Inspection Photos

Location Name: TEP ROCKY MOUNTAIN LLC SOUTH LEVERICH 13-09 Pad

Location #: 335045

Photo # 8993 Rupture disc vent line does not comply with CECMC pressure safety device rules

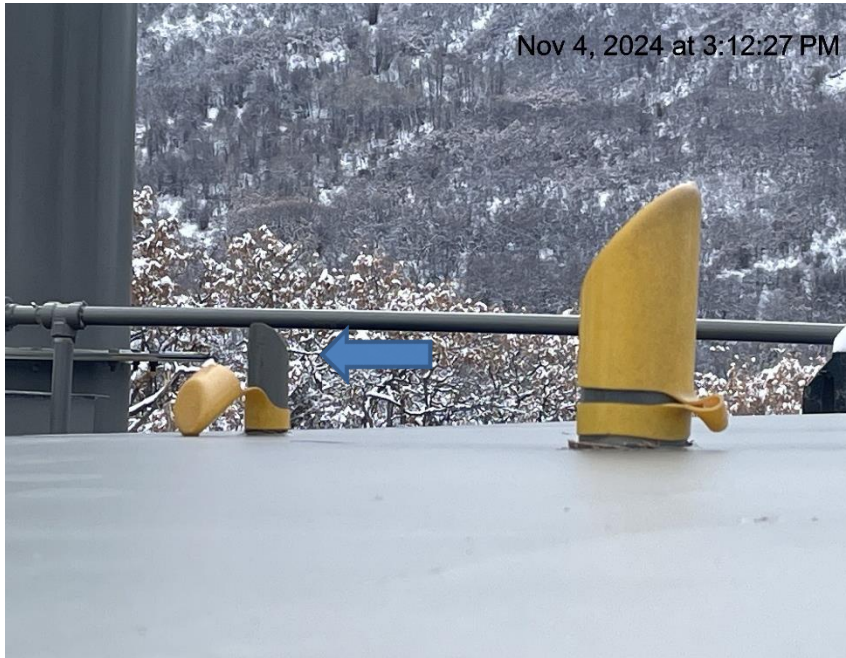
Photo # 8994 Rupture disc vent line does not comply with CECMC pressure safety device rules
